CHILDREN'S HOSPITAL
OF ORANGE COUNTY

TOWER II

LEVEL 5 ENLARGED PLAN
AHEAD - M

A3.5M

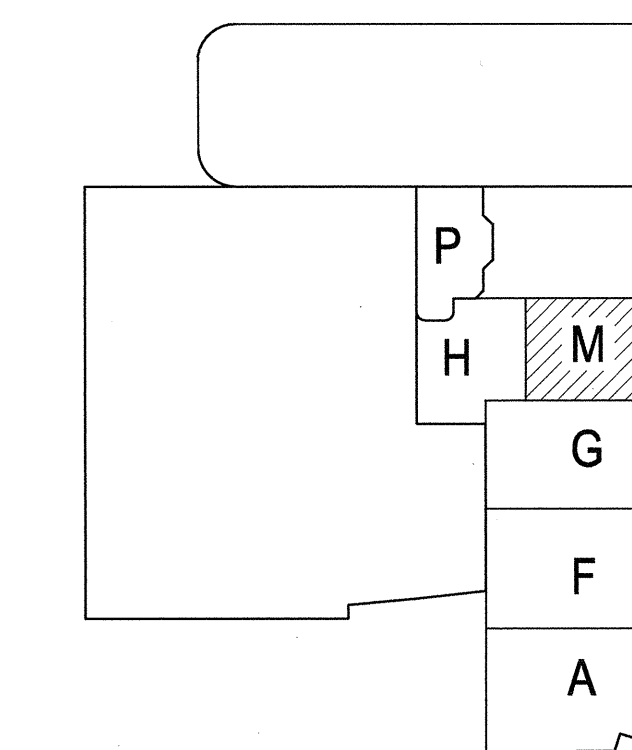
RFI 4107
Screw types and spacing
for FR backer behind 5th
floor headwalls in patient
rooms.

RFI 3655
Change wall type
and provide sound
attenuation blanket
at ceiling

RFI 4165 Install
TV2

RFI 3044
5 Tier Lockers

RFI #5602

RFI 526.1
See Sched.
A11.0.7

RFI 1824
Ref for finish
type

RFI 2241
Partition
16.4s
1'-7 1/2"

RFI 3475
PES enclosure wall
type, 12.4AS
custom, typ.

RFI 4415
Millwork/Counter top
Door Frame Conflict

RFI 4036
Ref RFI for installation
method of mop sink.

Note: RFI 318
Changed WC-4 to WC-3 at Non-ADA
toilets. Locate WC-3 15" from wall.

RFI 2324
Panels to be 1'-3" AFF
14"x14"
